SERVICE BULLETIN

No. 300-2-95

Subject: Inspection of upper longeron at the horizontal stabilizer attachment.

Figure 7: V-tubes and gussets for EA 300/L in 4130n (Kit No. SB295E3-2).

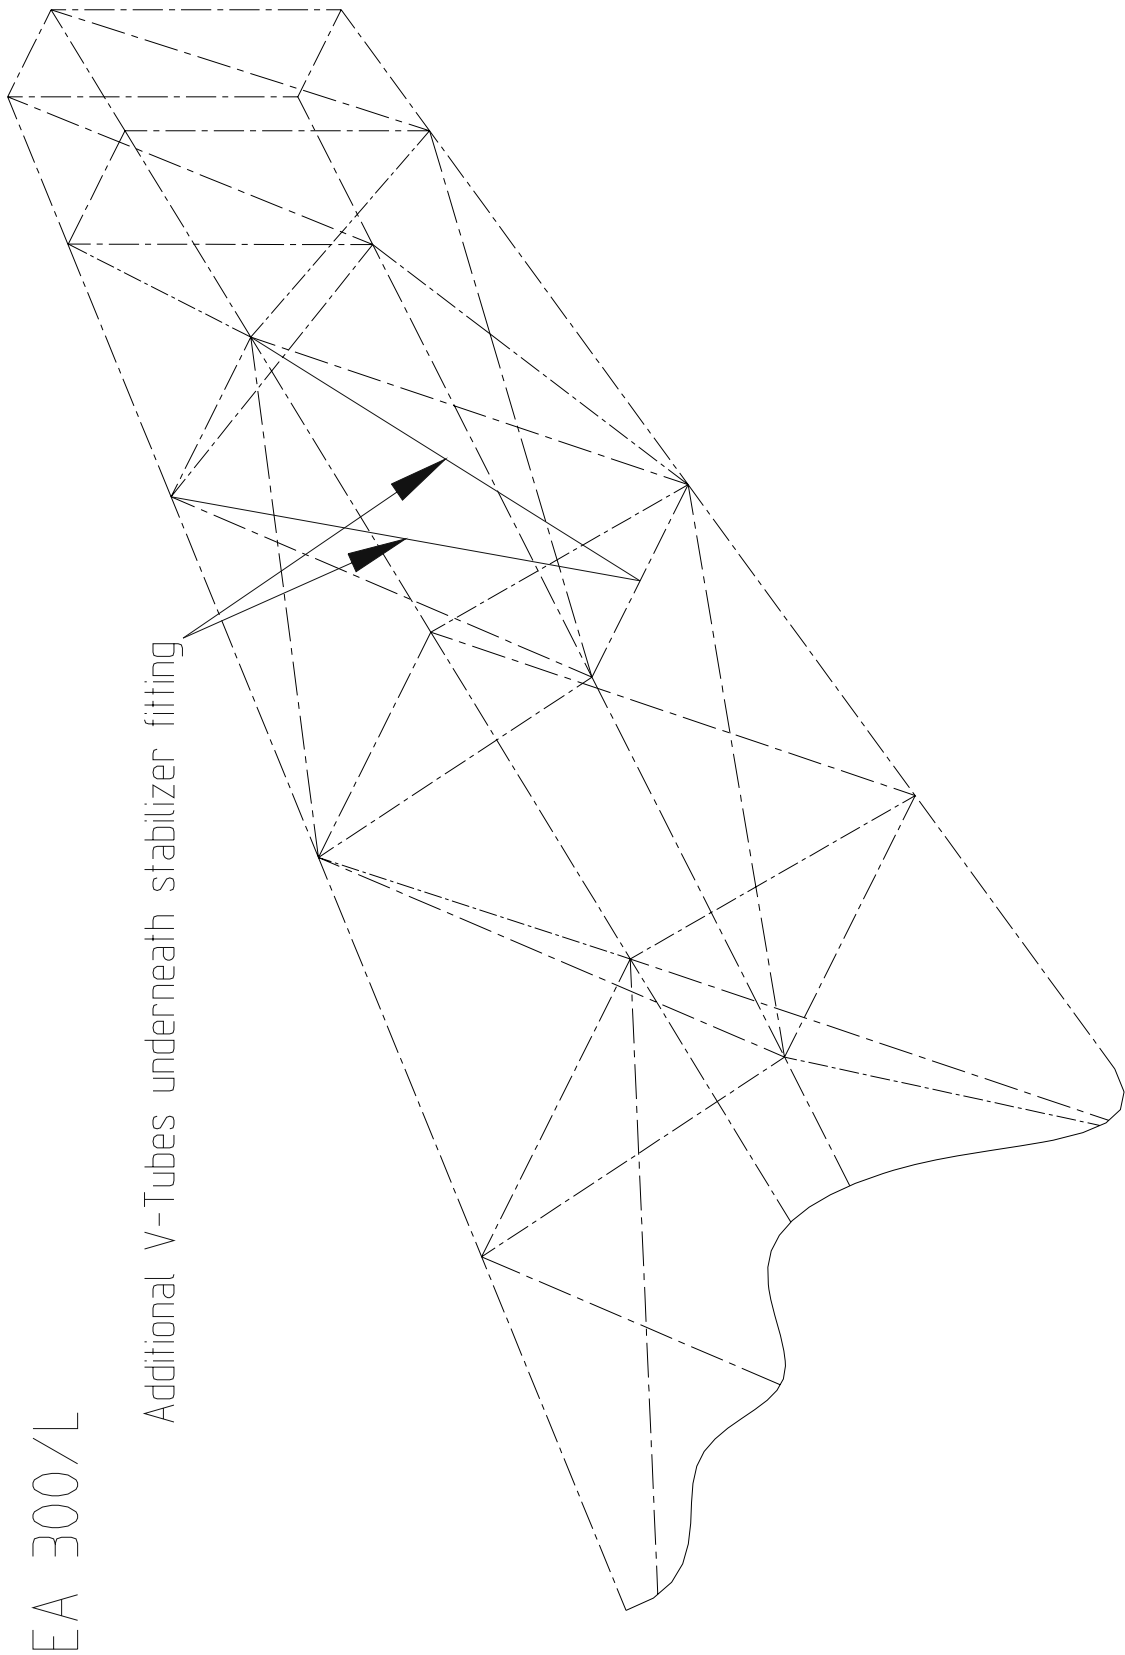
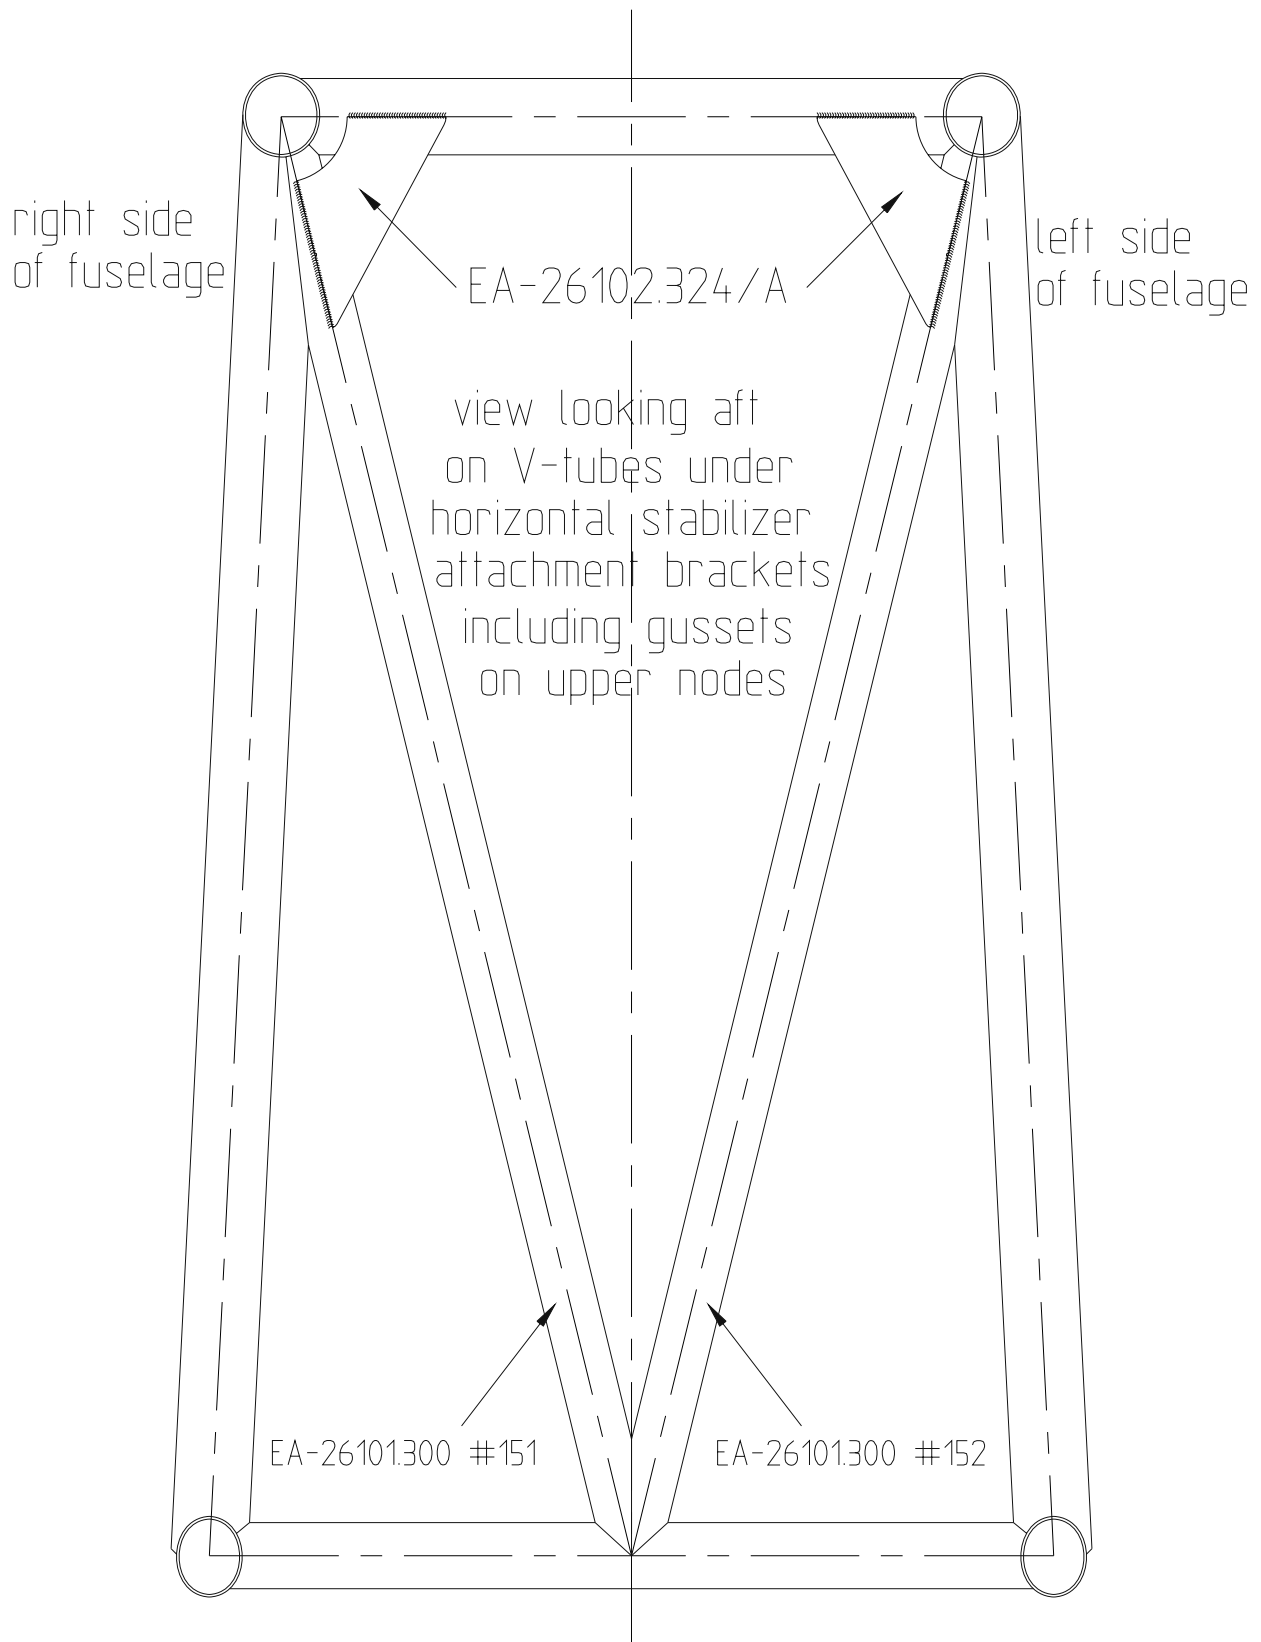
The additional V inserted into the fuselage frame underneath the horizontal stabilizer main spar attachment bracket serves the same function as a diagonal, but without interference with the elevator push-pull control. The higher stiffness of the frame against in-plane deformation minimizes local stress concentrations adjacent to the stabilizer attachment bracket reinforcements when the structure is experiencing elastic deformation under flight loads. This modification was included in the type design of the 300/S and 300/L from certain advanced serial numbers on in order to offer compatibility with an envisioned enlarged empennage with related higher tail loads.

- Make sure the V-tubes match the existing structure according to the applicable Figures (see Table 2).

- For the protection of the tube interior fill a small amount of corrosion preventive compound like ACF-50 or equivalent into each of the V-tubes.
- Weld V-tubes in place and check proper fit of gussets according to the applicable Figures (see Table 2) and weld them in place.
